**From:** [Michael Zimbleman](#)  
**To:** [Koepsell, Arthur](#)  
**Subject:** comments on Myers 21-06CH from Centennial Ridge subdivison  
**Date:** Friday, March 23, 2012 1:05:21 PM  
**Attachments:** [Centennial Ridge comments Myers 21-06CH.pdf](#)

## **Centennial Ridge (Centennial Mesa View) Comments/Suggestions wrt proposed Hilcorp Energy well: Myers 21-06CH**

## ACCESS ROAD MAP MYERS 21-06CH

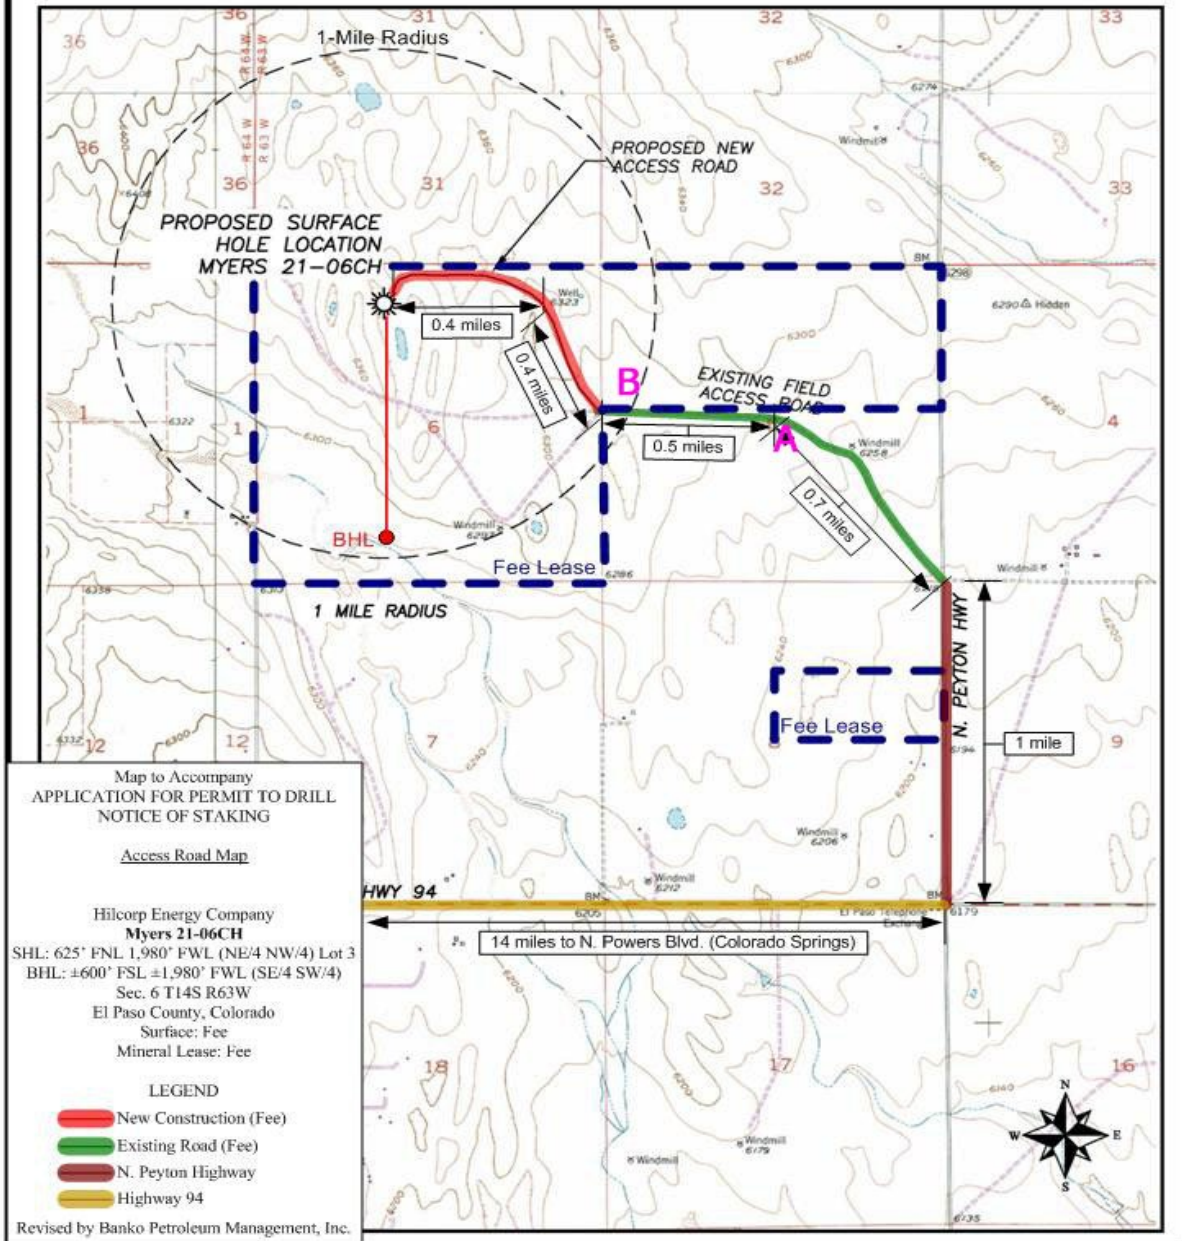
We request that the access road for Myers 21-06CH be moved from the proposed location adjacent to Centennial Ridge subdivision to a location along the north boundary of the leased property, approximately one-half mile to the north. The access road shown on the Hilcorp Energy application documents proposes to use what is shown as an unimproved road on the USGS quadrangle, and identifies it as an 'existing field road'. This is in fact not a road in any real sense. It is a jeep track/cow path used to repair ranch fence and by cattle as an easy path to the nearest water tank. We have attached photographs of this track. As can be seen in the photos the track could not be used for the volume of traffic expected for an oil well; a complete road construction would be required.

The location we request would proceed due east from the well site to Peyton Highway, and would be well over 1/2 mile from any residences. The road would follow the boundary fence between two ranches. The nearest structure would be a cattle barn approximately 3/8 mile north of the relocated road near its junction with Peyton Highway. This route should have the same construction requirements as the route in the application, but would be about one-half mile shorter in length. This should result in less expense to Hilcorp Energy for construction and maintenance. We have included a photograph from the application showing the view to the east from the well site. The existing track at that location is similar to the track along our subdivision boundary.

Application road map from Hilcorp Energy. Have added identifiers A and B to show locations from which our photographs were taken.
